Access Compliance Report Public Rights-of-Way (Curb Ramps)

Main Street: MADISON_AVE Cross Street: JEFFERSON_ST Location: NW

ADA ID: RPRK211004113200 Ramp Type: Type 1 - Perpendicular Diagonal Initial Pass/Fail: Fail Overall Compliance: No Severity Score: 20

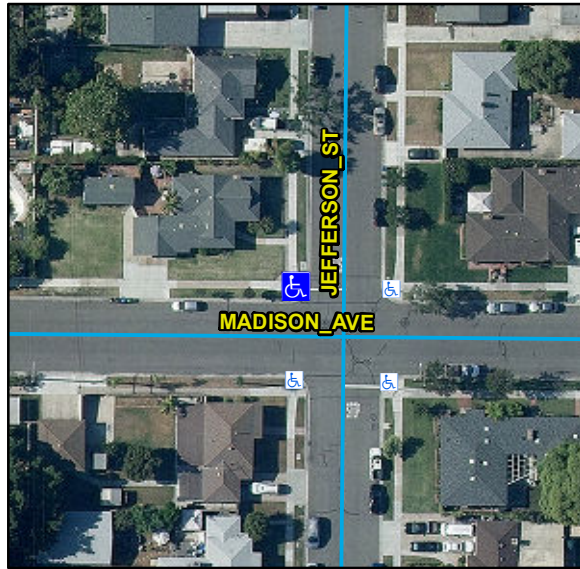
R304.2.2, R304.5.1, R304.5.3, STD 1115

Compliance	Description	Data	Compliance	Description	Data
N/A	Ramp Length (in)	105	N/A	Flare Type LT	
No	Ramp Width (in)	36			N/A
No	Ramp Run Slope (%)	11.2	N/A	Flare Slope LT (%)	N/A
No	Ramp Cross Slope (%)	2.1	N/A	Flare Traversable LT	N/A
N/A	Landing Present	N/A	N/A	Flare Type RT	
N/A	Landing Length (in)	N/A			N/A
N/A	Landing Width (in)	N/A	N/A	Flare Slope RT (%)	N/A
N/A	Landing Run Slope (%)	N/A	N/A	Flare Traversable RT	N/A
N/A	Landing Cross Slope (%)	N/A	N/A	DWS Provided	N/A
N/A	Landing Movement Obstructed?	N/A	N/A	DWS Contrast	N/A
	Landing Movement Type	N/A	N/A	DWS Length (in)	N/A
N/A	Landing Shared	N/A	N/A	DWS Full Width	N/A
N/A	Clear Space	Yes	N/A	DWS Offset Left (in)	N/A
N/A	Clear Space To Crosswalk (in)	N/A	N/A	DWS Offset Right (in)	N/A
N/A	Marked Crosswalk 1	No	N/A	Marked Crosswalk 2	No
	Crossing 1 Direction	S		Crossing 2 Direction	E
	Marked Crosswalk 1 Width (in)	N/A		Marked Crosswalk 2 Width (in)	N/A

N/A	Ramp Inside Crosswalk 1	N/A	Yes	Ramp Inside Crosswalk 2	N/A
	Crossing 1 Slope (%)	5.9		Crossing 2 Slope (%)	2
	Crossing 1 Cross Slope (%)	1.9		Crossing 2 Cross Slope (%)	3.9
N/A	Gutter Ponding	N/A	No	Curb Slope	9
Yes	Gutter Lip Height (in)	0		Road Run Slope (%)	3.1
N/A	Gutter Run Slope (%)	N/A		Road Cross Slope (%)	6
N/A	Gutter Cross Slope (%)	N/A			
Yes	Overall Surface Condition: Acceptable		Yes	Perp Joint Present	Yes
	Cross Gutter Present?	No		Spandrel Present?	Yes
	Replace Cross Gutter?	N/A		Replace Spandrel?	No

Remove & Replace Curb Ramp With Two New Directional Ramps or Equivalent.
